SI B65 11 13  
Audio, Navigation, Monitors, Alarms, SRS

This Service Information bulletin supersedes SI B65 11 13 **dated March 2013.**

**CIS Seat Mat Replacement**

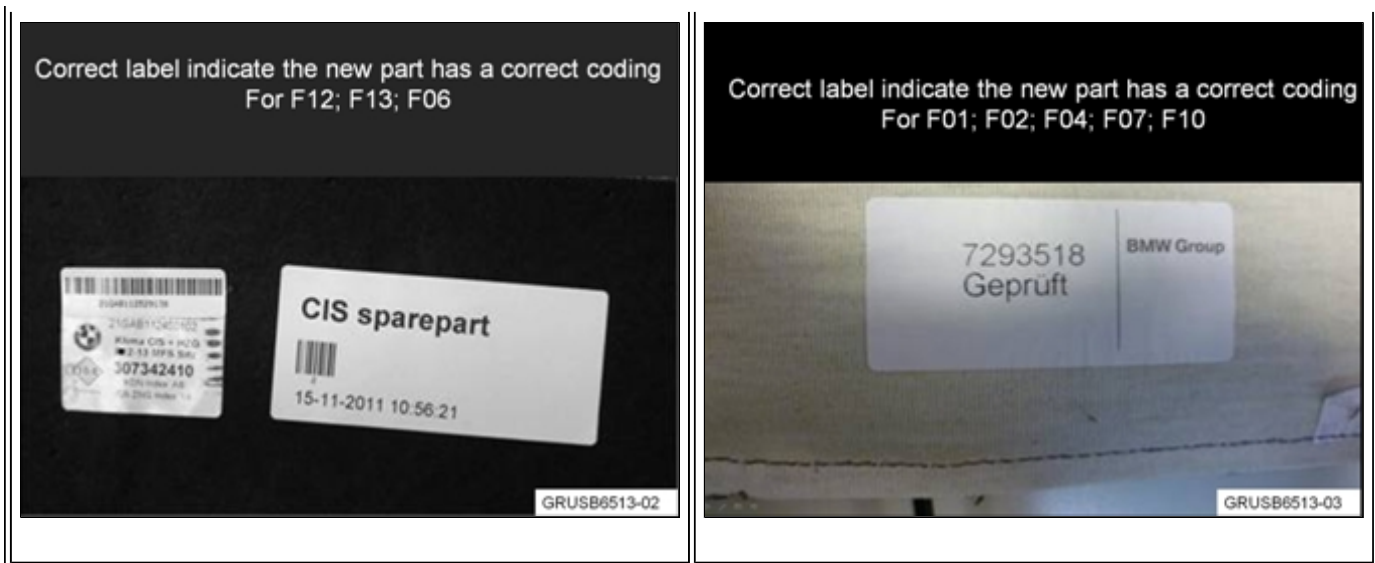
The pictures below are for a CIS seat mat that has the correct coding. The label should contain “CIS sparepart” or the German word “Geprüft” (tested).

Install the replacement CIS mat in the vehicle and code the ACSM (Advanced Crash Safety Module) with ISTA/P.

If the correct label is present; the new mat failed to enable; and the below faults are present, create a PuMA case for assistance. Make sure to attach a digital picture of the new seat mat to the case, as well as the original reason why the seat mat is being replaced.

If there is no label on the seat mat, reorder the new seat and submit a TTS PuMA case to the Parts Consultant Group, requesting assistance in obtaining the correct seat mat.
